AMENDMENT NO. 1 MARCH 2026

IS 15947 (PART 1) : 2020 CONCRETE DELIVERY PIPELINE

PART 1 SPECIFICATION

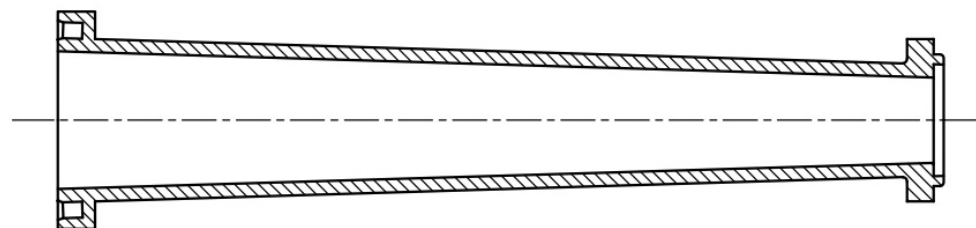
(Page 3, Notes 4) — Add the following at the end.

‘5 Pipes with 4.5 mm wall thickness may be used for practically all normal operations of concreting through concrete delivery pipeline, subject to the following maximum pumping pressures of concrete:

- a) For 100 NB pipes, pumping pressure shall not exceed 140 kg/cm²;
- b) For 125 NB pipes, pumping pressure shall not exceed 110 kg/cm²; and
- c) For 150 NB pipes, pumping pressure shall not exceed 90 kg/cm².

6 Pipes with 8 mm wall thickness shall be used for following higher pumping pressures of concrete pipes:

- a) For 100 NB pipes, pumping pressure shall not exceed 230 kg/cm²;
- b) For 125 NB pipes, pumping pressure shall not exceed 190 kg/cm²; and
- c) For 150 NB pipes, pumping pressure shall not exceed 160 kg/cm².

FIG. 4 REDUCER PIPE

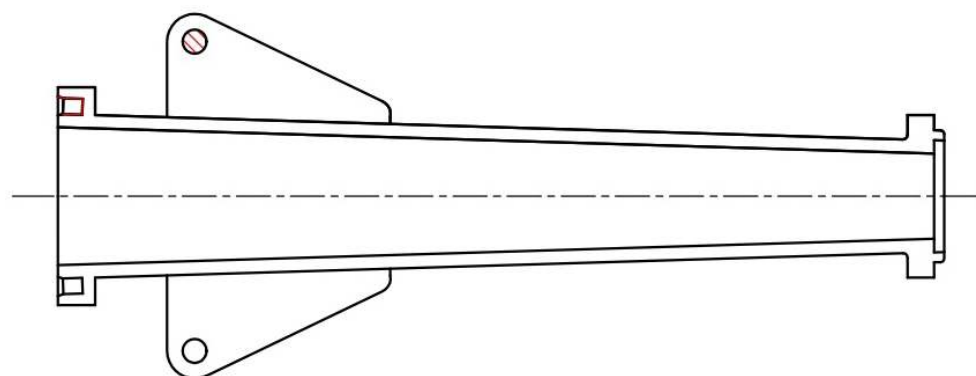
(Page 4, Fig. 4) — Substitute the following for existing:

REDUCER PIPE (PLAIN)

REDUCER PIPE (WITH EYES) – FOR TIGHTENING BY CLAMPING DEVICE
